UNITED STATES PATENT AND TRADEMARK OFFICE

APPLICATION NO.	FILING DATE	FIRST NAMED INVENTOR	ATTORNEY DOCKET NO.	CONFIRMATION NO.
10/720,341	11/25/2003	George J. Mathews	5377-002-27	3918
24510	7590	12/12/2006	EXAMINER NGUYEN, TAM M	
DLA PIPER US LLP ATTN: PATENT GROUP 1200 NINETEENTH STREET, NW WASHINGTON, DC 20036			ART UNIT 3764	PAPER NUMBER

DETAILED ACTION

FIG. 4

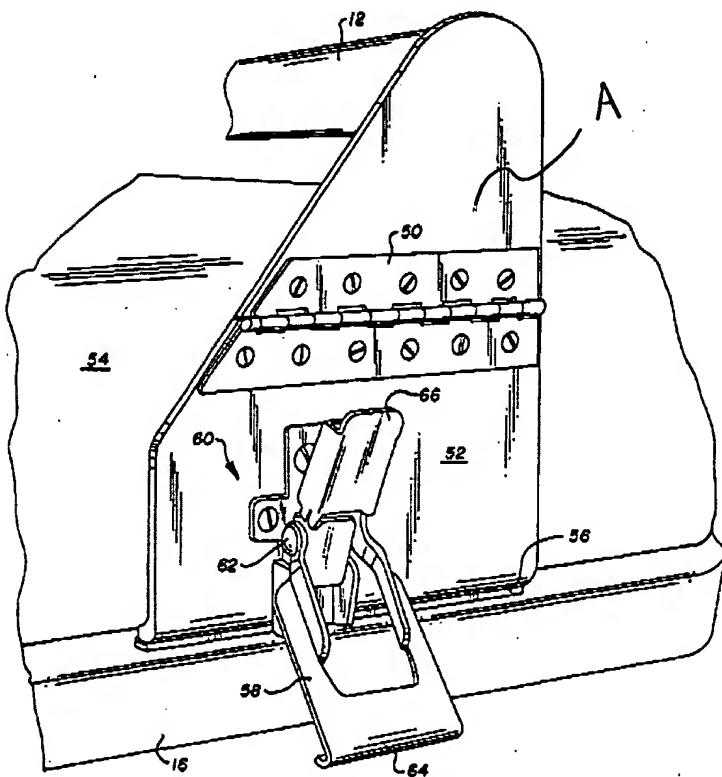
10. As to claim 3, McJunkin and Kepiro disclose a modified exercise device as described above (see discussion of claim 2). Kepiro further discloses a housing that encloses both receiving ends, and said mounted housing extends orthogonally from the first portion (A) of the top-side unit (see Fig. 4 above).
